**PLANNED UNIT DEVELOPMENT &  
PLANNING APPROVAL STAFF REPORT****Date: September 17, 2009****DEVELOPMENT NAME**

St. Luke's Episcopal Upper School

**LOCATION**1400 South University Avenue  
(South side of University Boulevard, 490'± East of Grelot Road)**CITY COUNCIL  
DISTRICT**

Planned Unit Development approval to amend a previously approved Planned Unit Development to allow multiple buildings on a single building site and to allow the addition of new baseball, softball, and football fields, all associated backstops and dugouts for new fields, moveable bleachers and a new ground maintenance storage building and Planning Approval (Master Plan) to amend a previously approved Planning Approval to allow the addition of a new baseball, softball, and football fields, all associated backstops and dugouts for new fields, moveable bleachers and a new ground maintenance storage building at an existing school in a B-1, Buffer Business District.

SITE PLAN

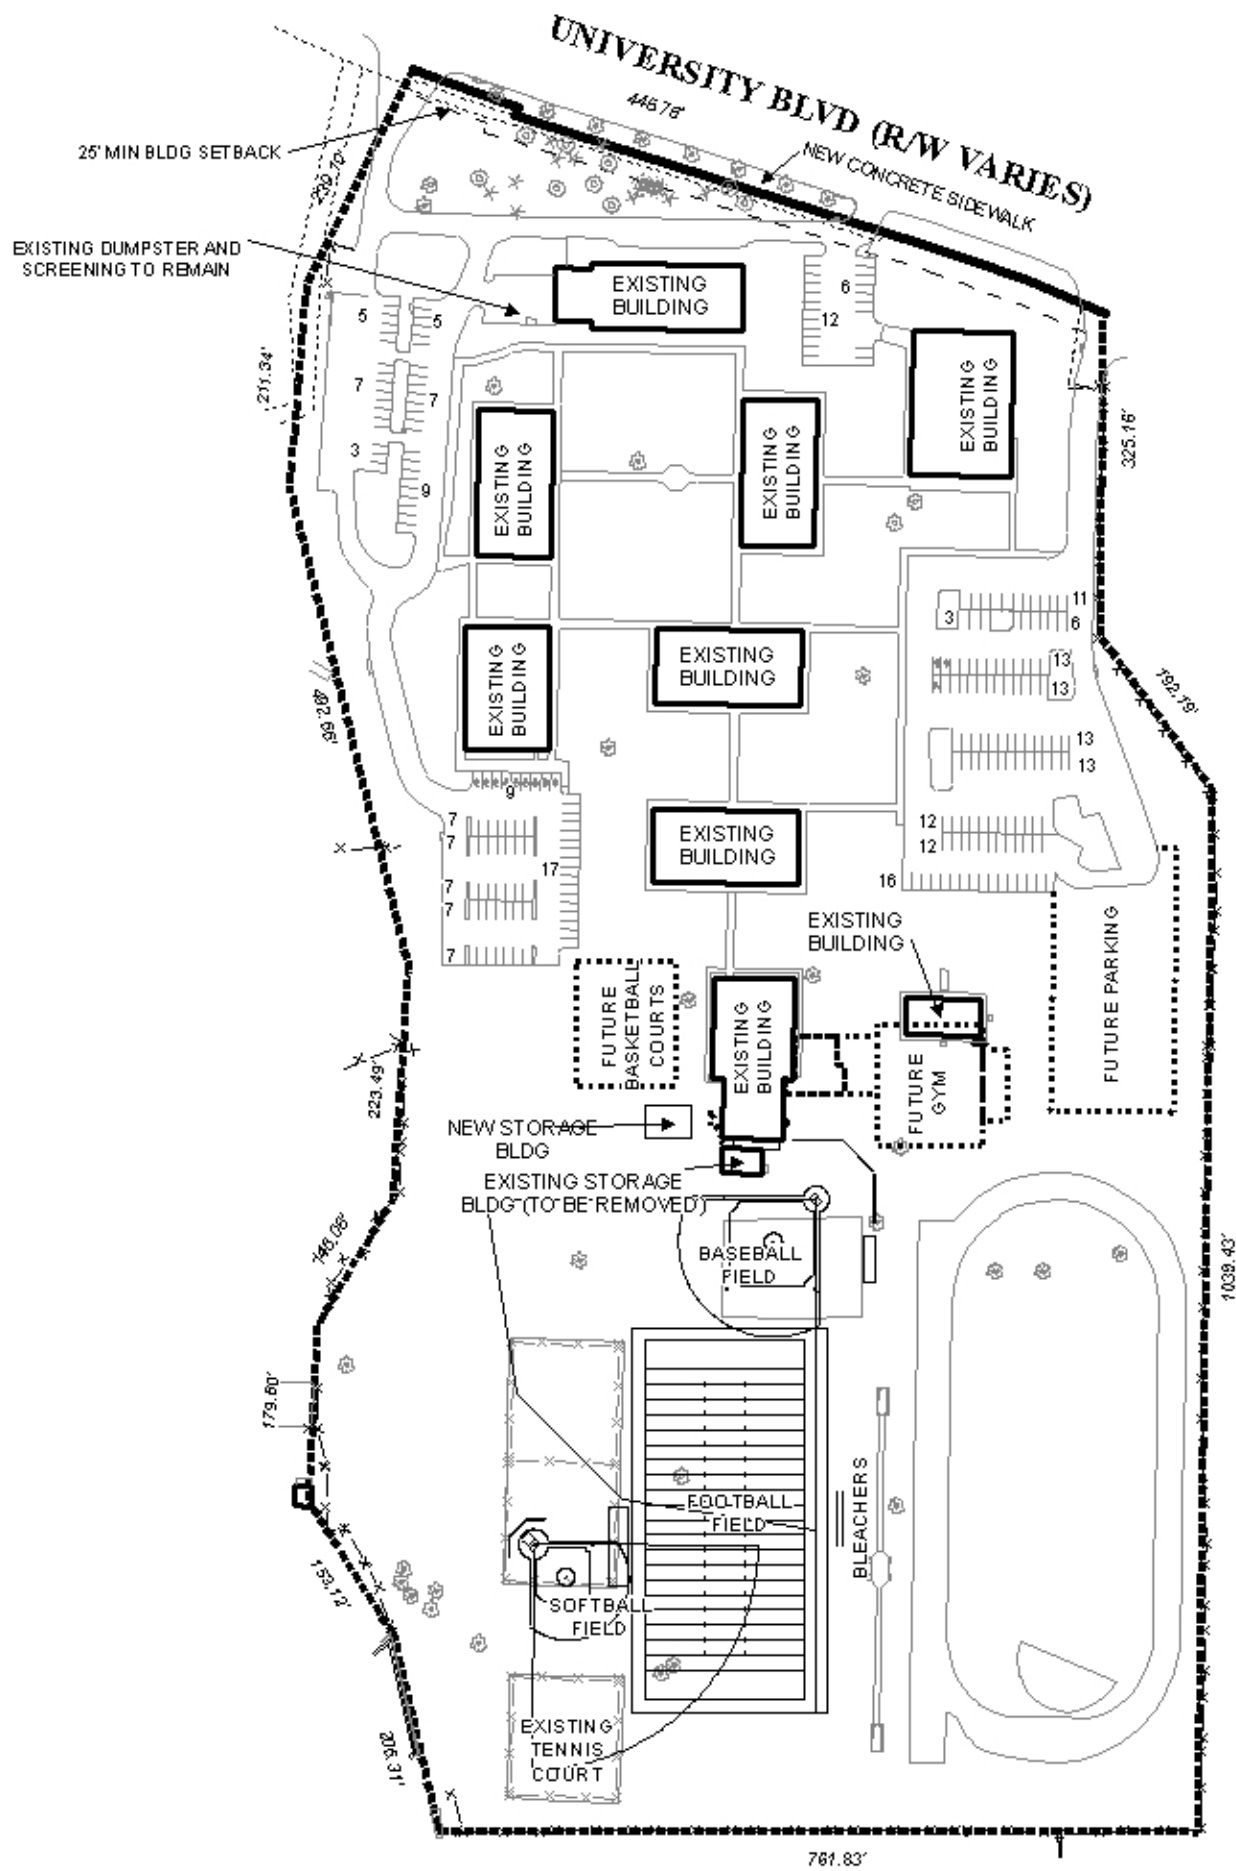
It should be noted that the westernmost curb cut seems to be within the adjacent undeveloped property; therefore, a condition noted on the site plan stating that a Planned Unit Development (PUD) would be required when this site is developed.

As mentioned previously the site plan illustrates a “future gymnasium and basketball courts”. A separate Planned Unit Development (PUD)/Planning Approval application will be required for these additions, or the current applications should be heldover and revised.

No on-site storm water detention facilities are depicted on the site plan, however such facilities may be required due to the extent of the proposed new development.

There is indication on the site plan as to the existing location of the dumpster or other waste storage facility. The location of the storage area for the dumpster is indicated on the site plan, required screening must comply with Section 64-4.D.9. of the Zoning Ordinance, as well as with all other applicable regulations.

Regarding compliance with the tree and landscape requirements of the Zoning Ordinance, the applicant illustrates a significant number of frontage trees along South University Boulevard; however, no percentage of frontage landscaping is illustrated. Since no addition is illustrated or proposed within the front of the existing buildings and the total existing landscaping of 70 percent greatly exceeds the minimum requirements of the Ordinance, the approval should be approved based on the percentage of front landscaping that exists today.

As the reorientation of the softball field, new baseball and football fields may effect adjacent residences, the applicant should be aware that these fields would only be used during daylight hours since light standard design, placement and photometric were not included with the application.

3. provision of consultation with Engineering Department on the placement, design and construction of the sidewalks along University Boulevard South prior to July 17, 2010;
4. illustration of any additional dumpster or trash receptacle, with **minor** revisions to parking and circulation layout to be approved by Planning staff, if necessary;
5. full compliance with the total landscaping and tree planting requirements;
6. full compliance with all municipal codes and ordinances; and
7. submission of a revised site plan reflecting the conditions prior to the issuance of any permits

1. lighting of parking facilities shall be provided in compliance with Section 64-6.A.3.c of the Zoning Ordinance;
2. provision of a 20-foot vegetative buffer along the South property line from Lot 1, Wright's Place Subdivision to the interior lot line of Lots 4 and 5 of Wright's Place Subdivision, this vegetative buffer shall comply with protection buffers; screen planting of the Zoning Ordinance Section 4, D. Planting of the vegetative buffer shall be coordinated with the Planning and Urban Forestry sections of Urban Development Department;

3. provision of consultation with Engineering Department on the placement, design and construction of the sidewalks along University Boulevard South prior to July 17, 2010;

4. illustration of any additional dumpster or trash receptacle, with **minor** revisions to parking and circulation layout to be approved by Planning staff, if necessary;

5. full compliance with the total landscaping and tree planting requirements;
6. full compliance with all municipal codes and ordinances; and
7. submission of a revised site plan reflecting the conditions prior to the issuance of any permits
